From: Brussel, John
Sent: Sunday, August 14, 2005 9:03 PM
To: aabarraz@gw.dec.state.ny.us
Cc: joel.robinson@bayermaterialscience.com; MOLINA, JOSEPH; khmurphy@gw.dec.state.ny.us
Subject: Modification to Demolition Work Plan - Bayer Hicksville
Attachments: Demo WP Modification.pdf; Figure 3_revised.pdf

**ATTACHMENT 1
MODIFICATION TO THE DEMOLITION WORK PLAN**

**BAYER MATERIALSCIENCE LLC
125 NEW SOUTH ROAD
HICKSVILLE, NEW YORK**

**PROPOSED & EXISTING
 CONCRETE SAMPLING LOCATIONS**

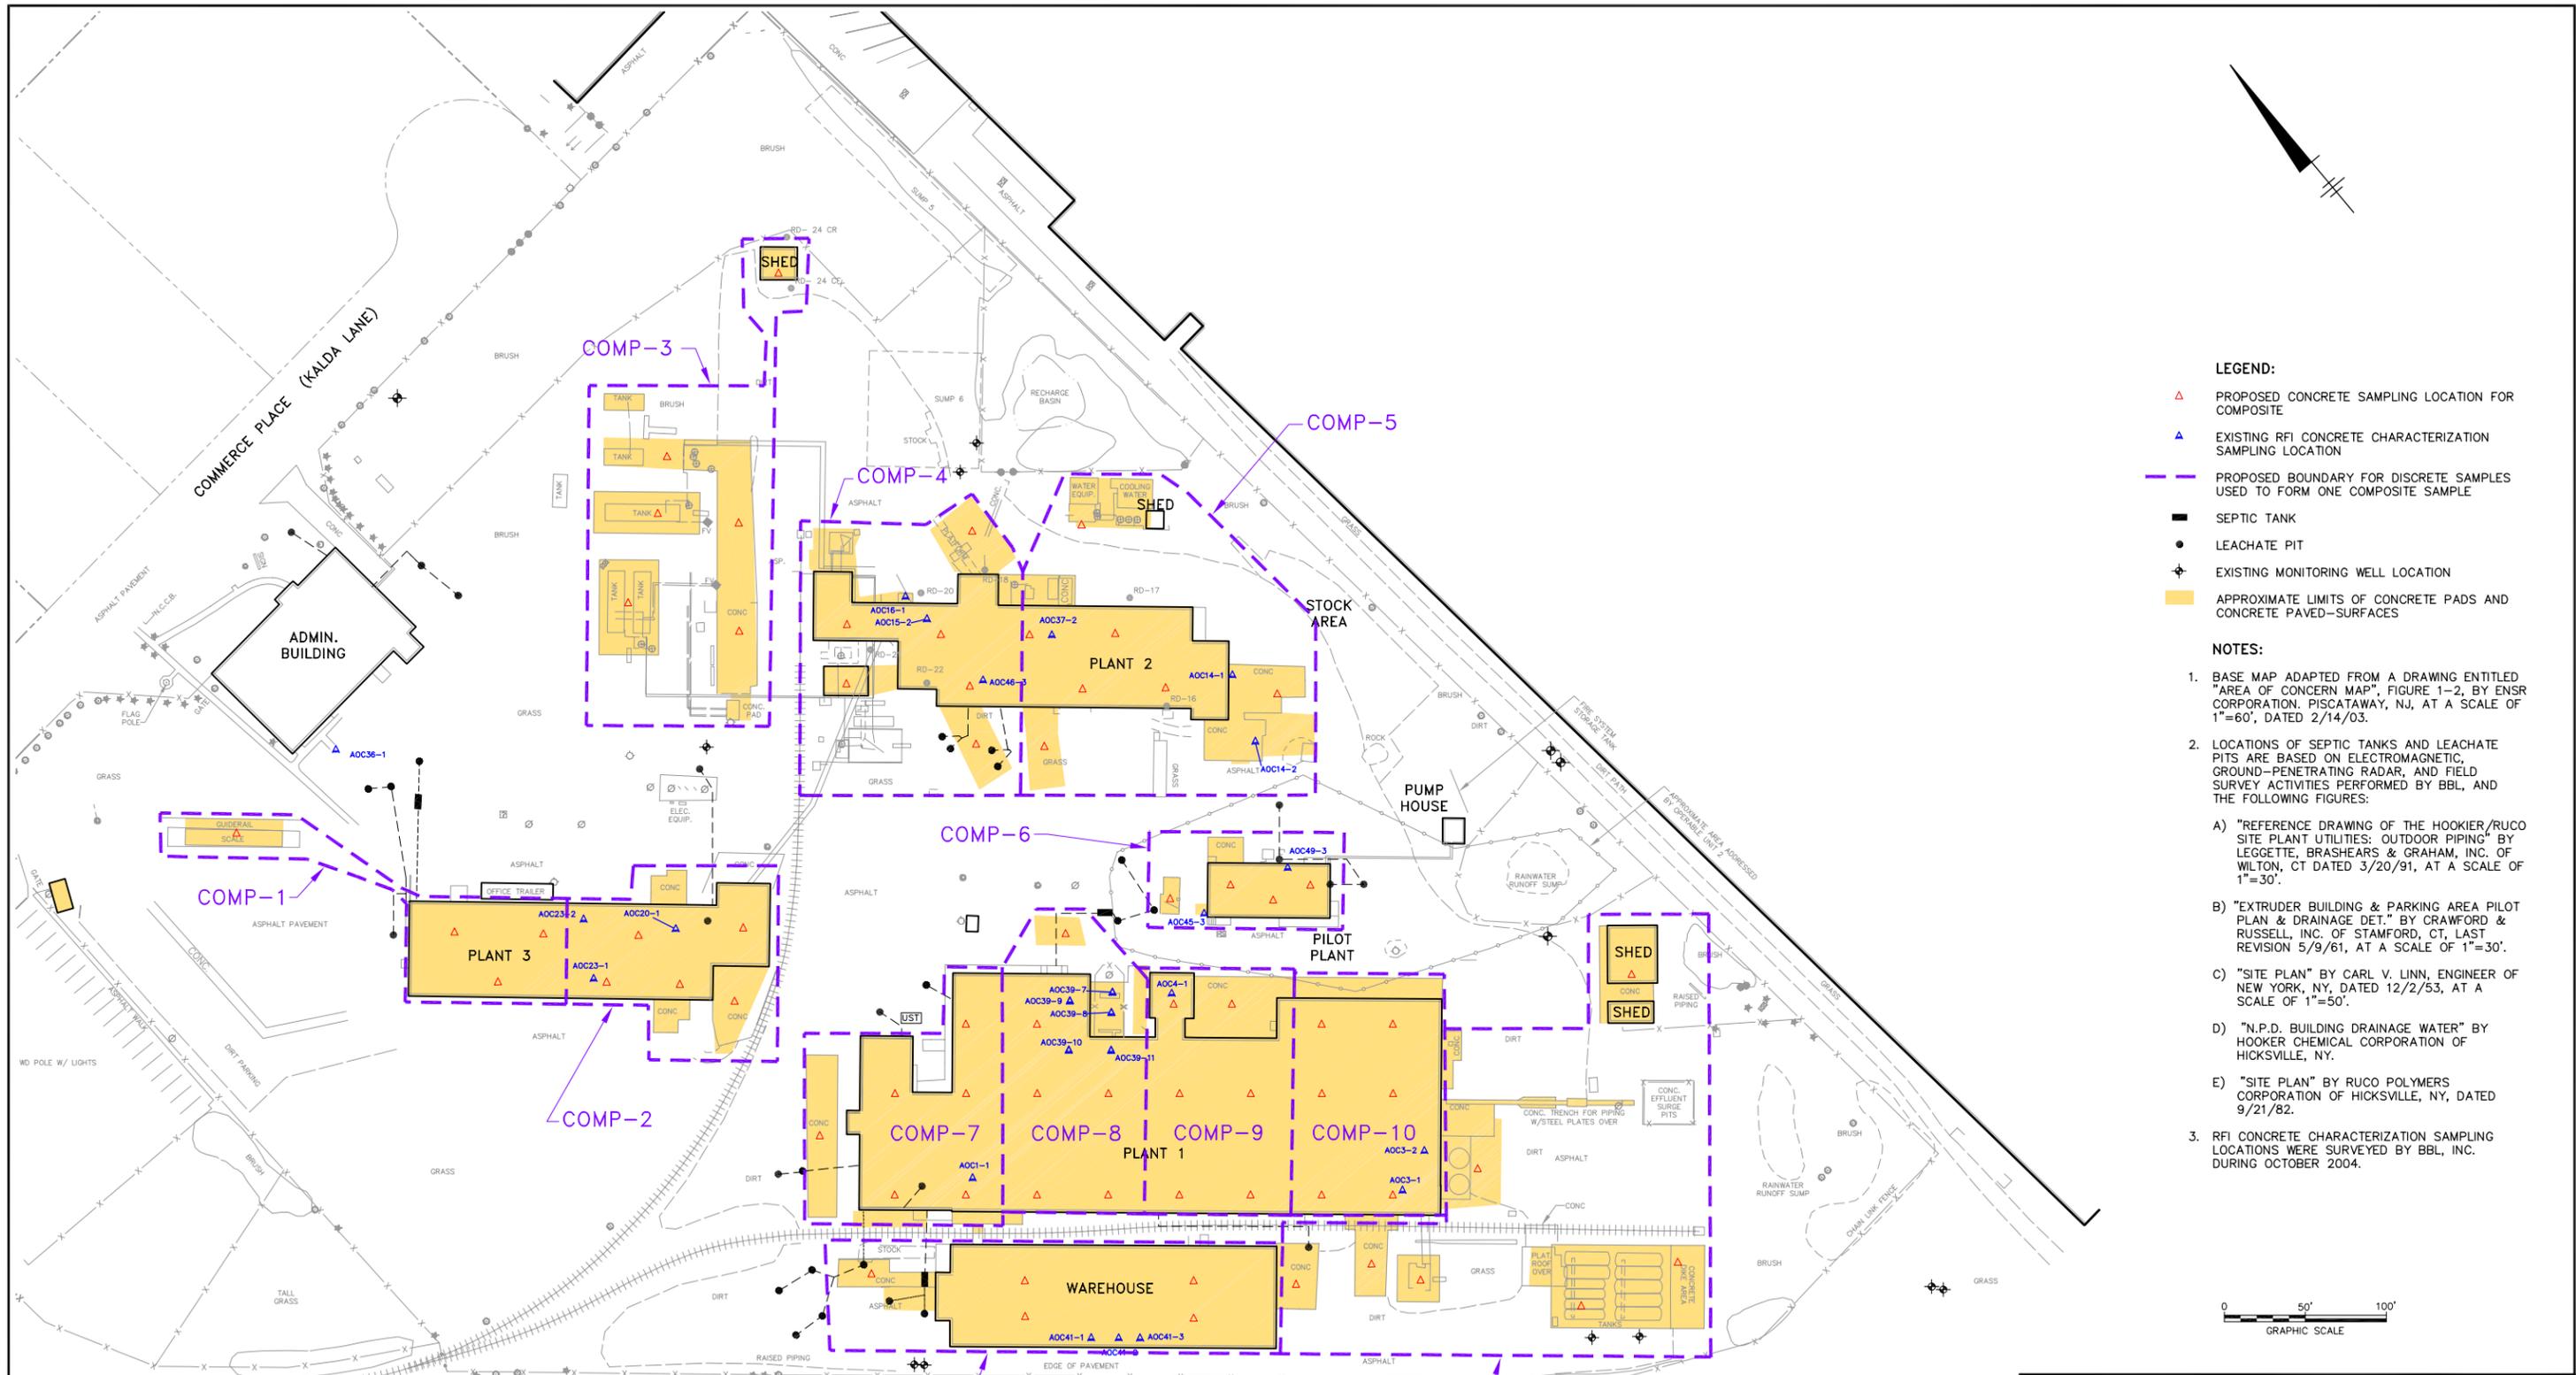
The total number of composite samples and discrete samples is insufficient. The building slab floors should be divided into grids and a minimum of one composite sample taken from each grid. The total number of composite and discrete samples for each grid will vary depending on the size and condition of the concrete, but they should be representative of the area being sampled. Discrete samples should focus on areas where cracks and staining (other than from petroleum spills) were observed from previous concrete sampling, as summarized in the table in section 1.3.4 (Previous Concrete Sampling).

There are also concrete areas outside of the floor slabs where no sampling or insufficient sampling is proposed. These areas should also be divided into grid(s) for composite samples, as described above.

Additional discrete and composite concrete core samples will be collected to further evaluate the presence and extent of PCBs in the former building concrete floor slabs and concrete-paved areas outside the floor slabs. Under the proposed revised sampling approach, a total of 68 representative discrete samples will be collected (instead of 39 as called for in the Demolition Work Plan). The proposed discrete sampling locations will provide additional coverage across the building floor slabs, coverage in concrete-paved areas outside the slabs where no samples were previously proposed, and coverage in the general areas identified in the table in Subsection 1.3.4 where possible staining/slight staining was noticed by field sampling personnel during the RFI. Discrete samples to evaluate concrete re-use will not be collected from areas where heavy staining is observed, because concrete from such areas will be segregated during demolition for proper offsite transportation and disposal.

Under the revised sampling approach, a total of 12 composite samples will be collected, each formed from four to seven discrete samples. The revised composite sample quantity equates to one composite characterization sample per approximately 310 cubic yards (CY) of concrete anticipated to be generated by the demolition activities. Locations where discrete samples will be collected to generate composite samples are shown as red triangles on the revised version of Figure 3 (see attached PDF file). The purple lines on Figure 3 designate boundaries for each composite sample. As indicated by the purple lines, the actual area of concrete to be characterized by each composite sample is approximately the same (just over 100 feet by 100 feet). An analytical sample summary, which identifies the proposed 12 composite samples, sampling areas, and corresponding number of discrete samples to form each composite, is presented below.

Under the revised sampling approach described in Response 1, sample coverage is now provided in each area outside the concrete floor slabs.
